Re: Rapiscan AIT System Radiation Survey Reporting

Rapiscan systems	Secure 1000 Radiation Emission Measurement	FORM R-0646-1 (Single Pose)
----------------------------	---	--------------------------------

R-0646-1 Addendum (Documentation Errors)

Product Name	Secure 1000SP (Single Pose)
Serial Number	S51009005
Radiation Emission Measurement	Radiation Survey Dated: 07/07/2010
RSO Initials	[REDACTED]

1. In Beam Dose Measurement: Survey Table. 1

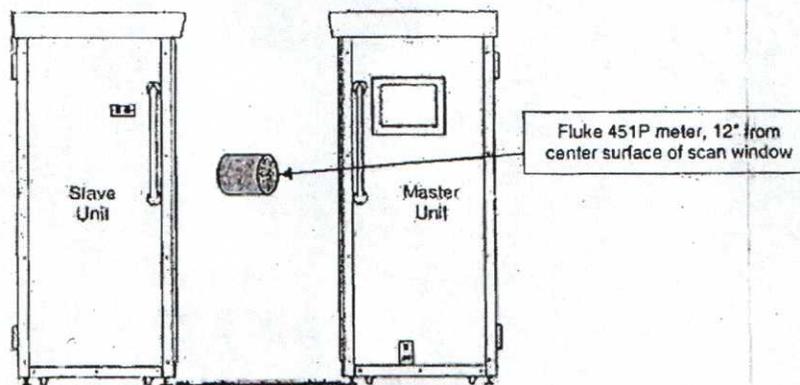
1. No value indicated for background radiation. Typical values range from 7uRem/hr to 13uRem/hr at sea level. Note: Absence of value has no adverse impact on calculations.
2. Technician indicated scan time as 7 seconds. Correct scan time is 3 seconds.
3. TABLE 1: Incorrect presentation of data in Column 3 for Measured Exposure. Indicated values are 45uR and 36uR. Corrected values are 4.5uR and 3.6uR. The values were corrected by technician when calculating Effective Dose.

The service technician should attend refresher training.

The corrected data indicates this system was operating within expected parameters. No re-survey is required for this system.
